**PROJECT SCOPING PLAN FOR PERFORMING A
CERCLA REMEDIAL INVESTIGATION/FEASIBILITY
STUDY (RI/FS) AT THE OPEN DETONATION
GROUNDS, SENECA ARMY DEPOT ACTIVITY**

**PROJECT SCOPING PLAN
REMEDIAL INVESTIGATION/FEASIBILITY STUDY
AT SEAD-45
SENECA ARMY DEPOT ACTIVITY
ROMULUS, NEW YORK**

**COMMENTS AND RECOMMENDATIONS
PRE-DRAFT PROJECT SCOPING PLAN
REMEDIAL INVESTIGATION FEASIBILITY STUDY
OPEN DETONATION GROUND (SEAD-45)
SENECA ARMY DEPOT ACTIVITY
ROMULUS, NEW YORK
FEBRUARY 1995**

PARSONS	
PARSONS ENGINEERING SCIENCE, INC.	
CLIENT/PROJECT TITLE	
SENECA ARMY DEPOT ACTIVITY RI/FS PROJECT SCOPING PLAN SEAD-45 OPEN DETONATION GROUNDS	
DEPT.	Dwg. No.
ENVIRONMENTAL ENGINEERING	728610-03001
FIGURE 3-3	
GROUNDWATER ELEVATION MAP	
APRIL 4, 1994	
SCALE 1" = 200'	DATE AUGUST 1995
REV A

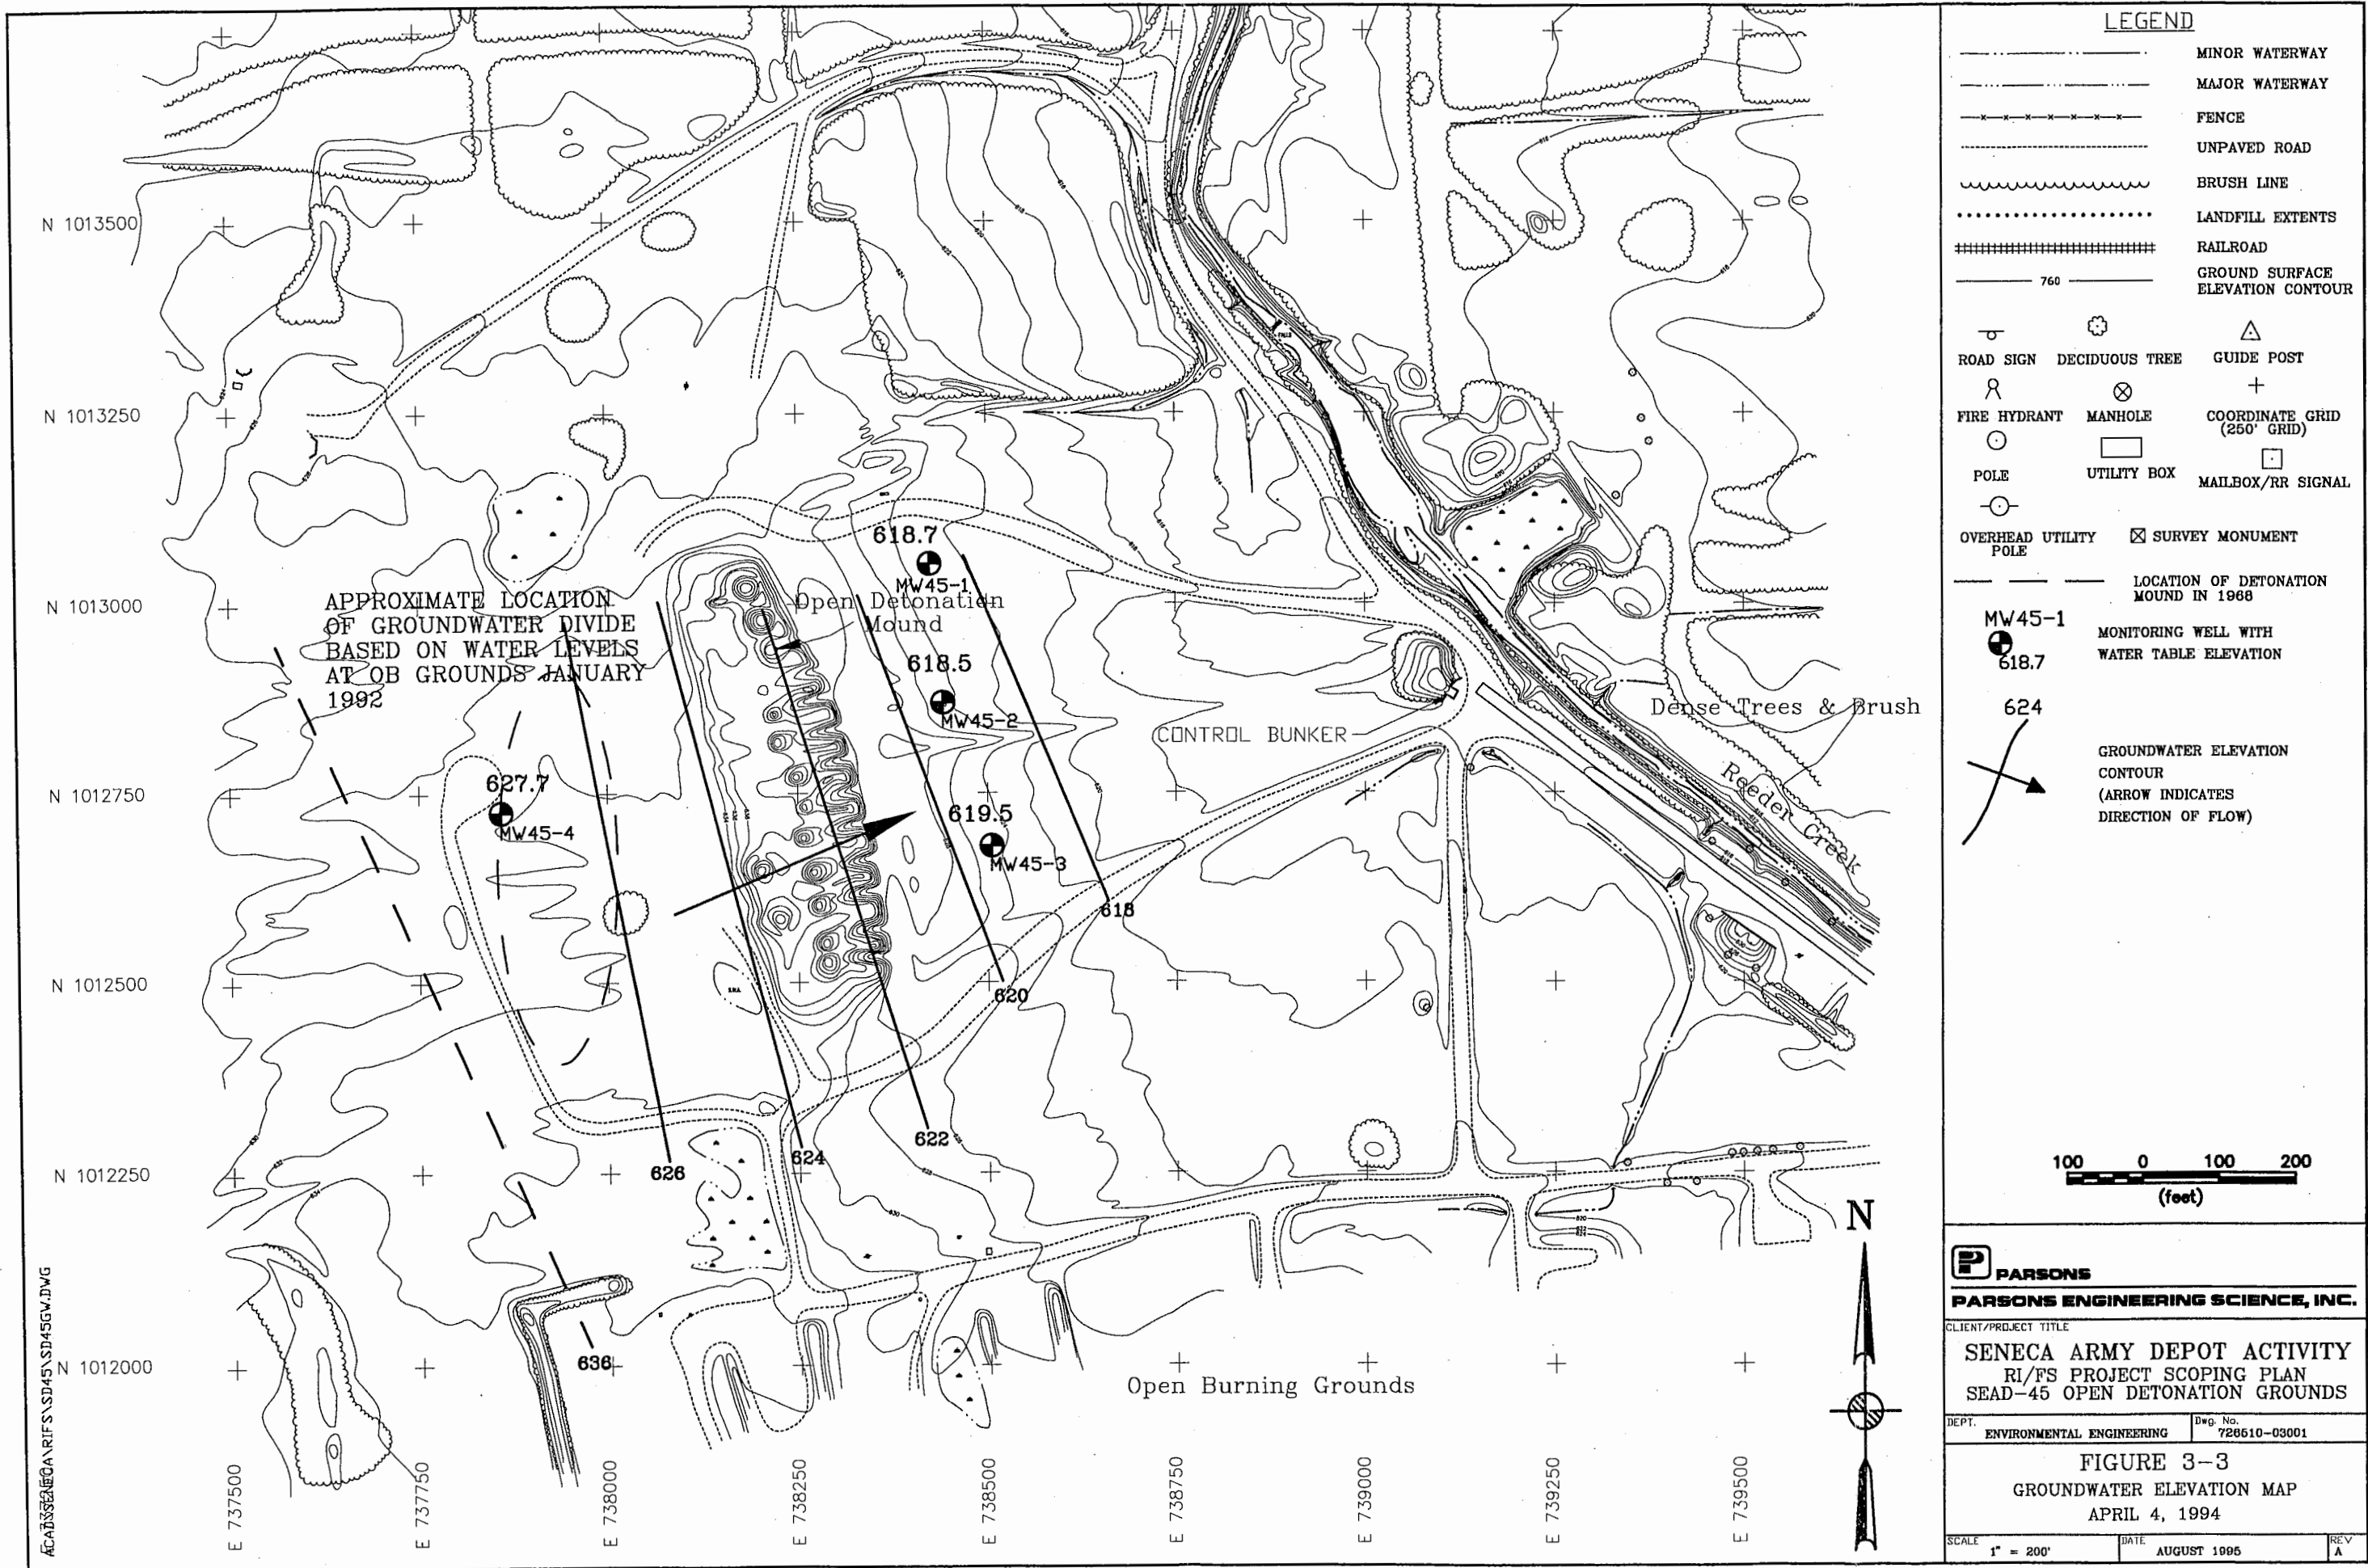
Comment #1 Page 3-7, Section 3, Figure 3-3, K. Butoryak - Groundwater Elevation Map.

Response #1 Agreed. The arrow indicating the direction of groundwater flow has been added to Figure 3-3.

FIGURE 4-1
PROPOSED SOIL BORING LOCATIONS

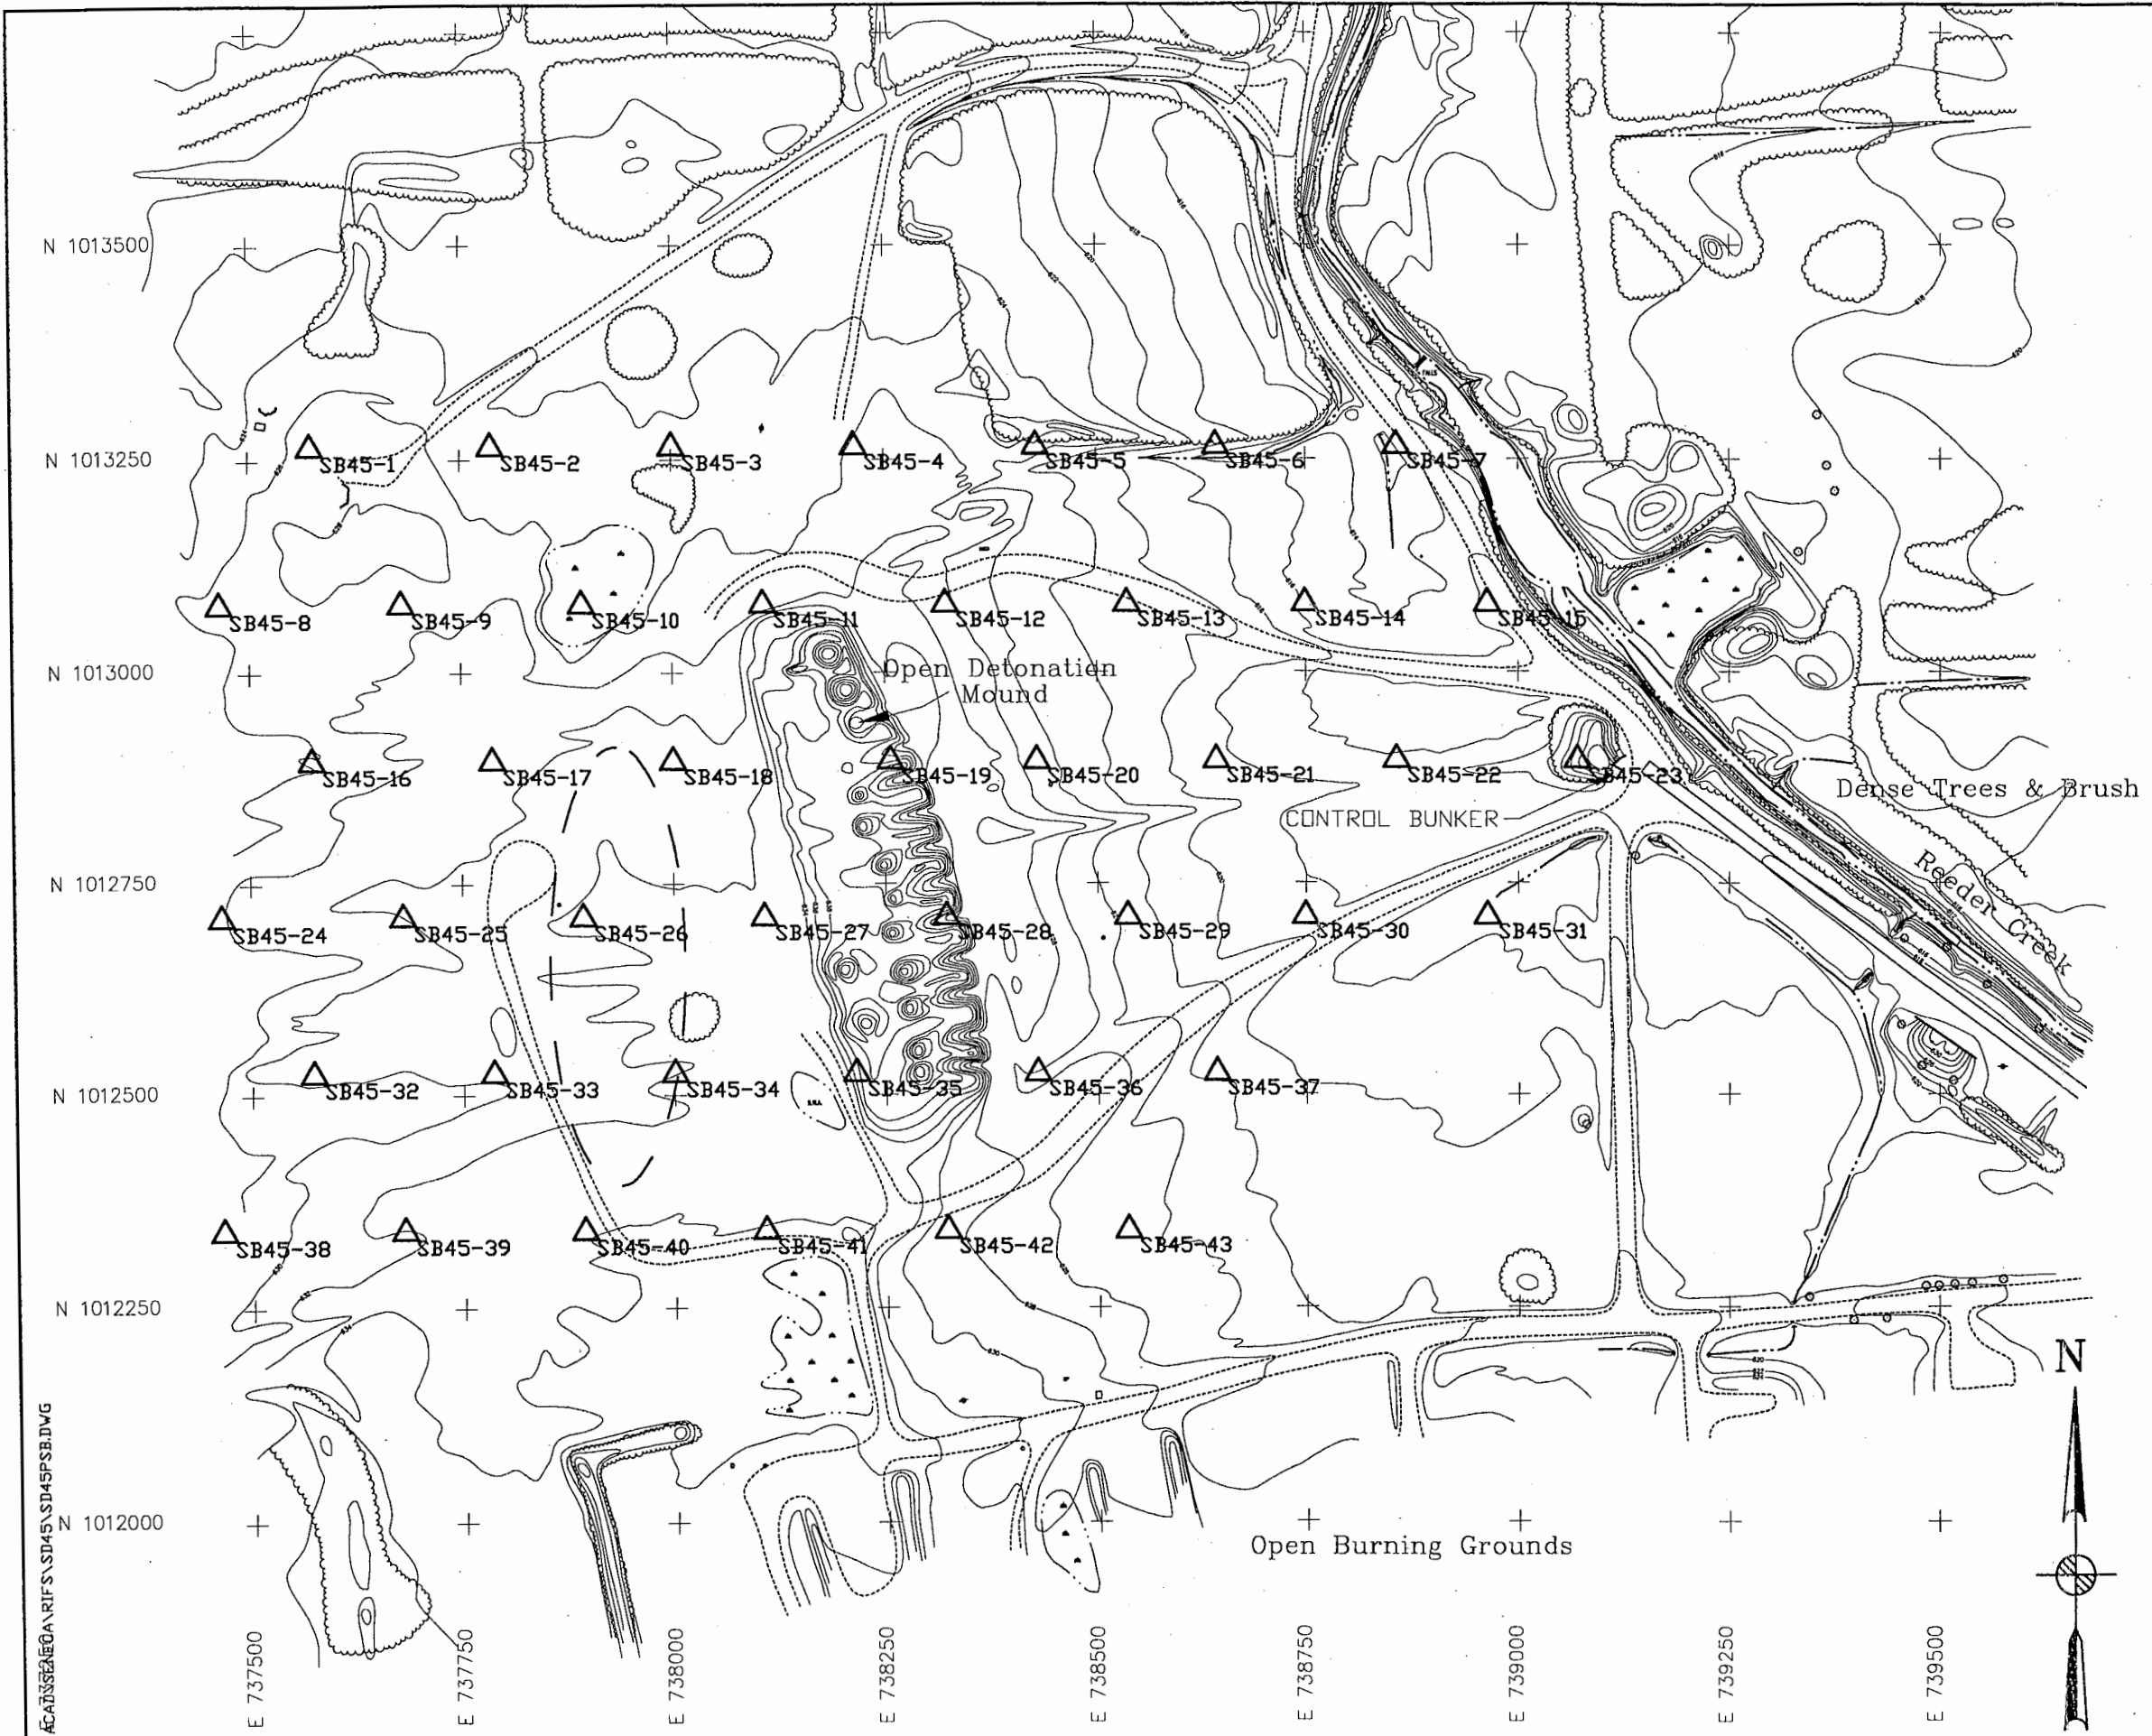
Comment #7 Page 4-11, Section 4.2.3.1,K. Butoryak - Monitoring Well Installation. This paragraph states that six additional overburden wells will be installed, while only five additional wells are proposed on pages 3-24 and 4-12. Additionally, Figure 4-1 depicts only five proposed monitoring well sites.

The paragraph states "Although MW-5 has been sampled in the past...it will not be sampled for this RI/FS because one of the new wells will provide coverage of the same area." Why is a new well being installed if the area is already covered? It is also unclear from Figure 4-1 which one of the new wells will provide coverage for this area.
